Name of Proposed Subdivision HARLAN PARK PHASE ONE

~~SITE PLAN/PRELIMINARY/PLAT~~ FINAL PLAT
FACT SHEET

Re: Harlan Park, Phase I
ROK 84811

Re: Second Review
Harlan Park, Phase I
ROK 84811

1 OF 17

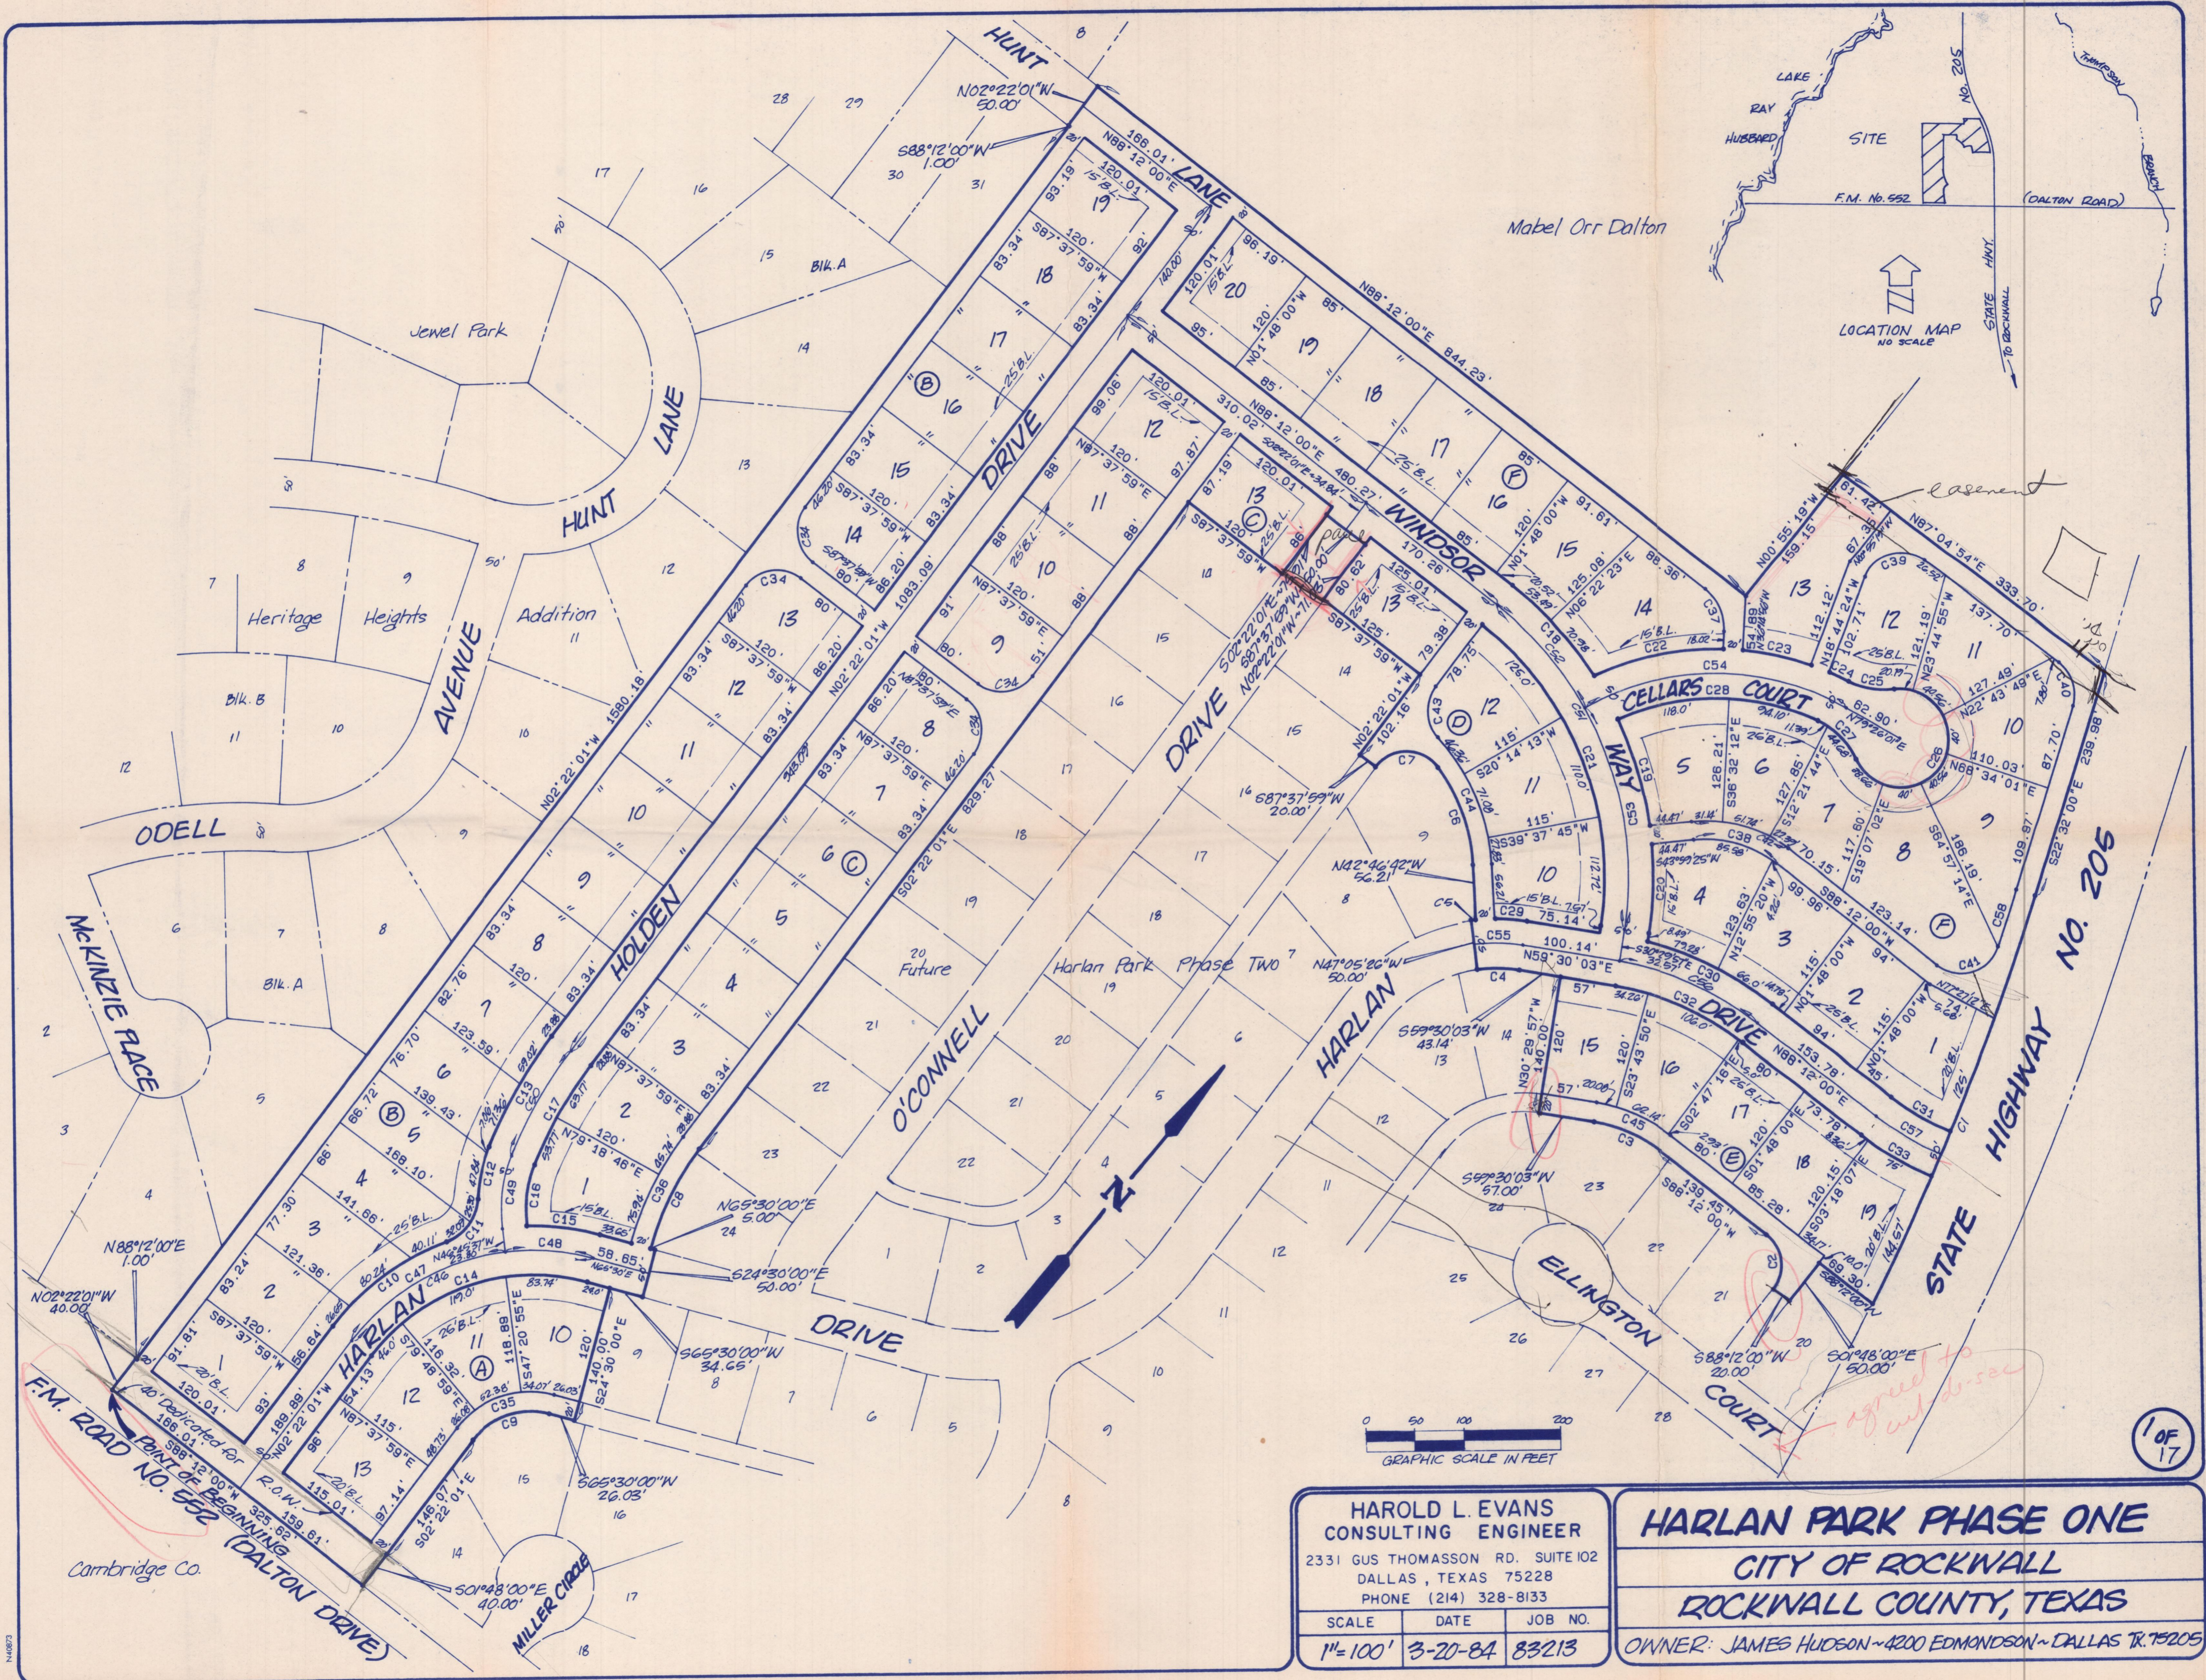
1. Dalton Road not FM-552
2. Need street access to Lot 13, Block C and Lot 13.
Block D
3. Need access to alley behind Harlan Drive
4. Consider easement across Lot 13, Block F
5. Consider reverse Ellington Ct. to access off
Harlan Drive

HARLAN PARK PHASE ONE
 CITY OF ROCKWALL
 ROCKWALL COUNTY, TEXAS

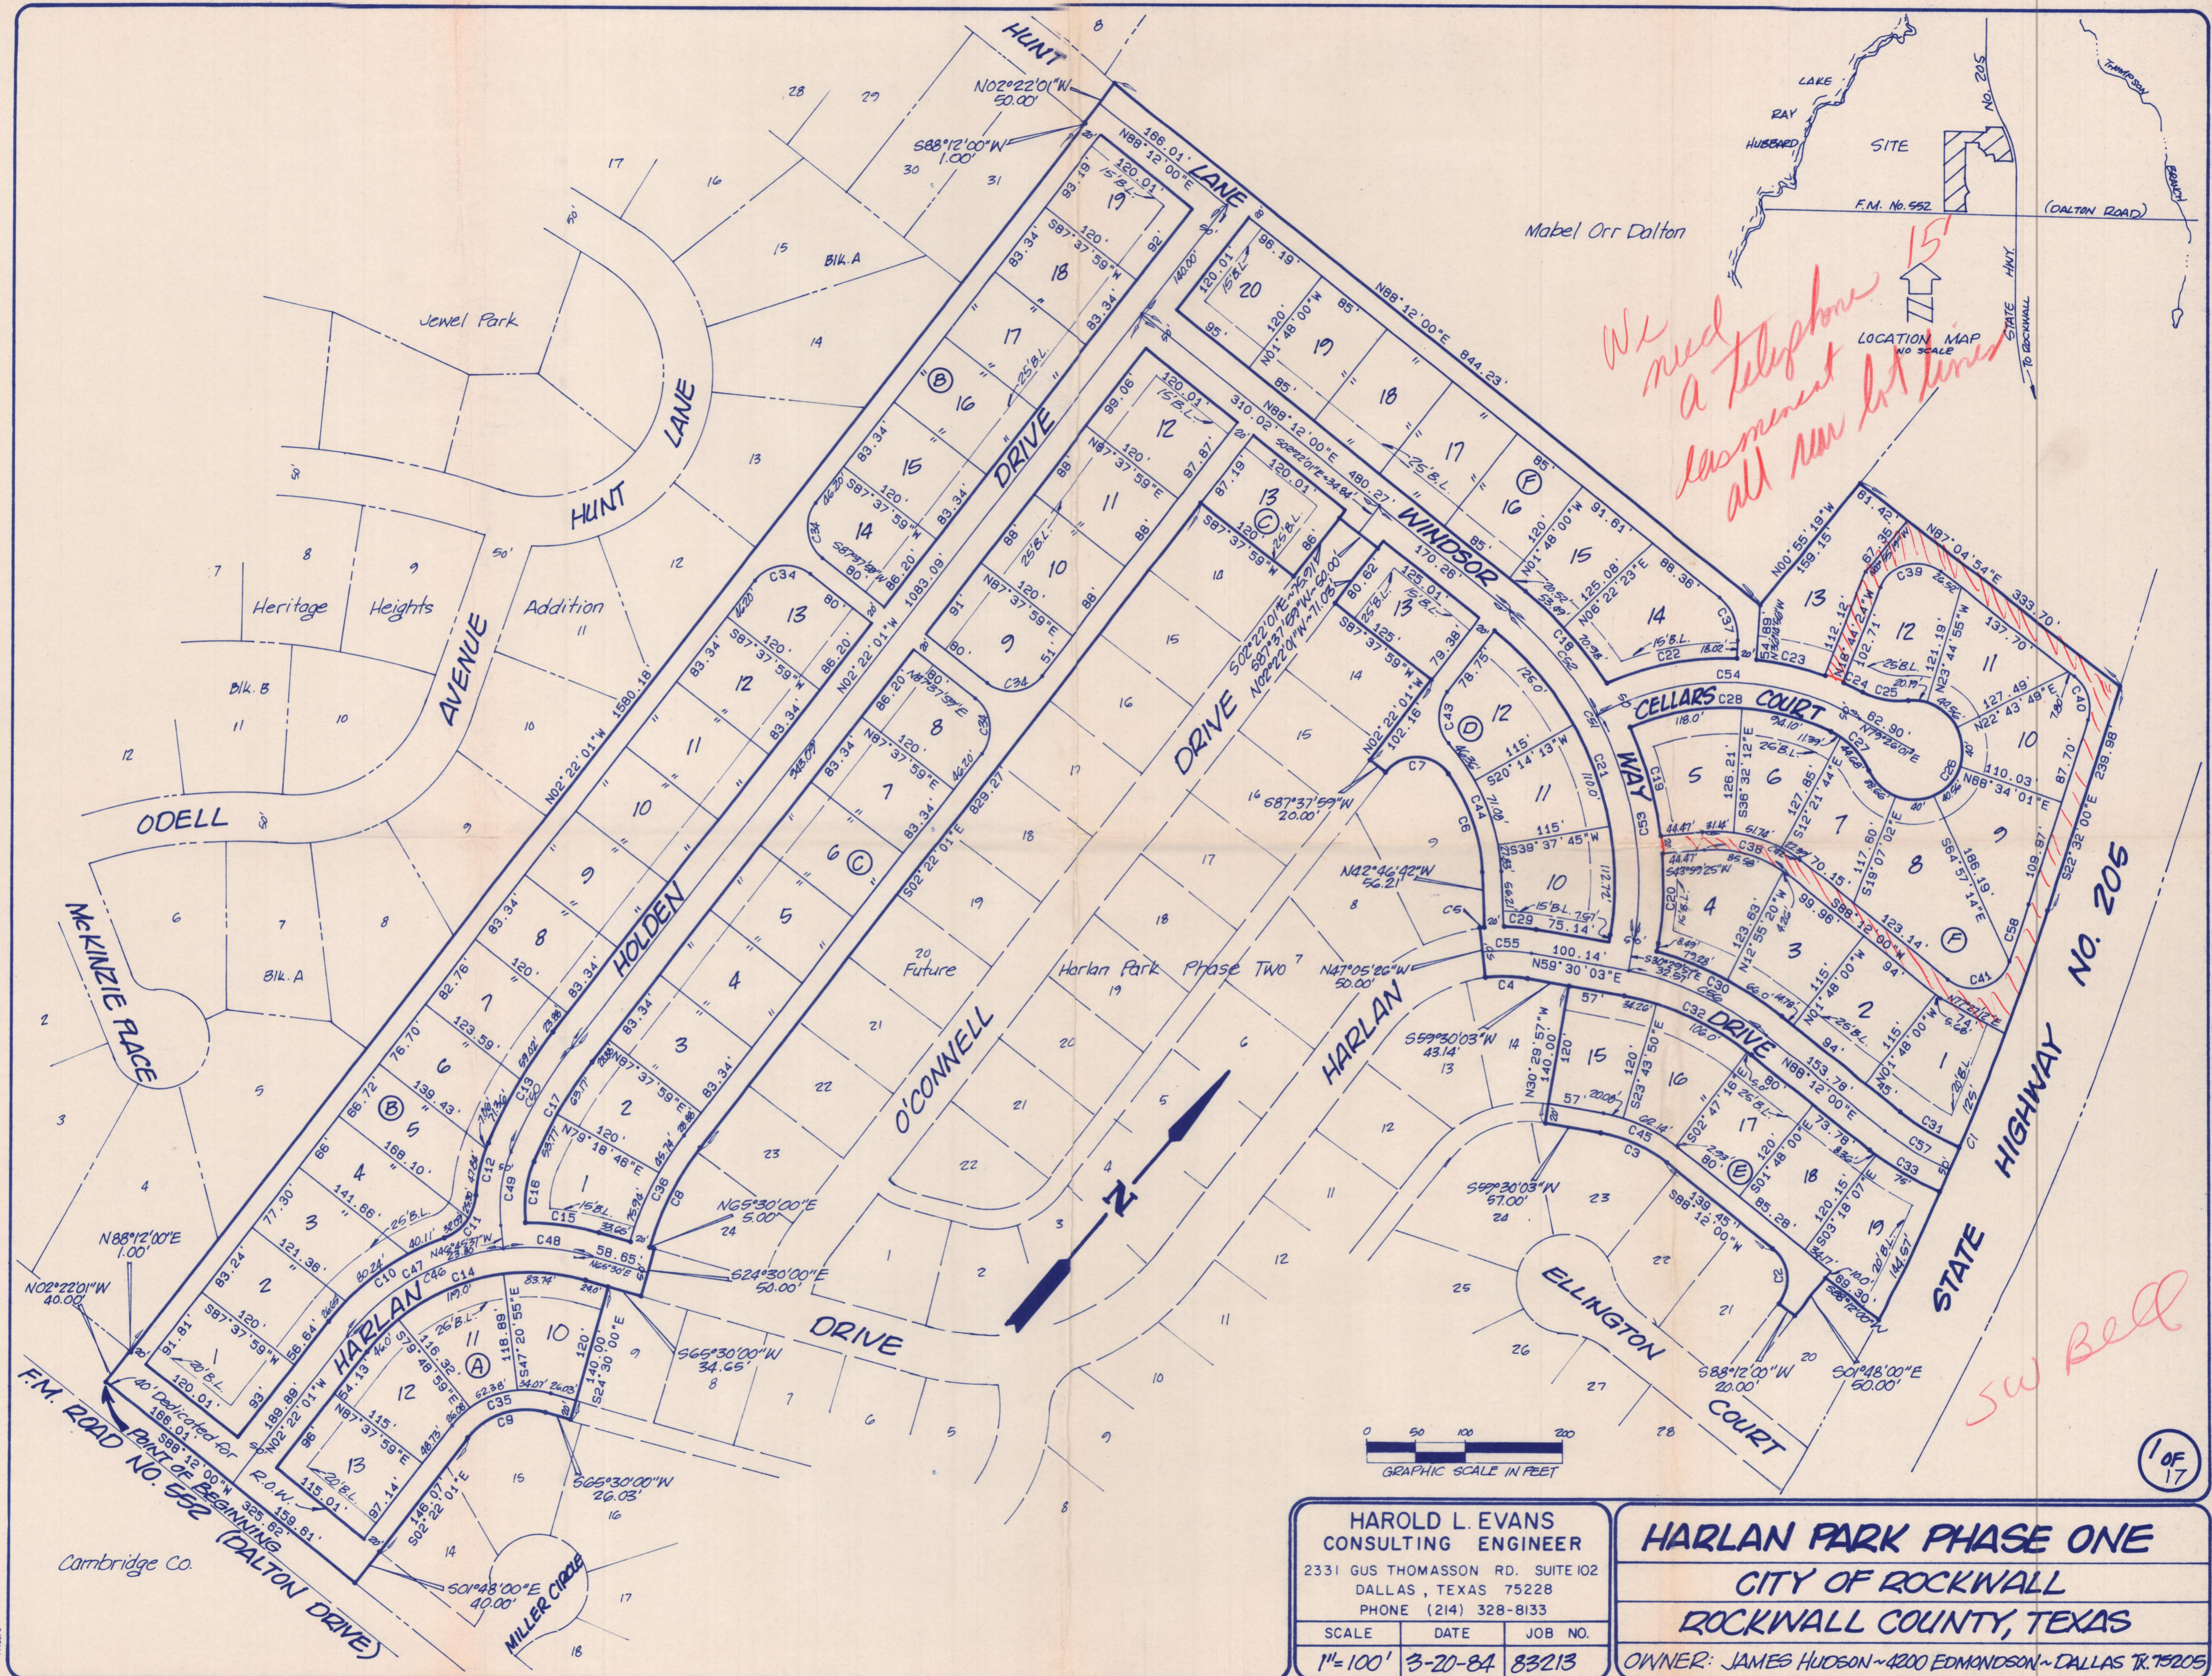
We need a telephone easement all new hot lines
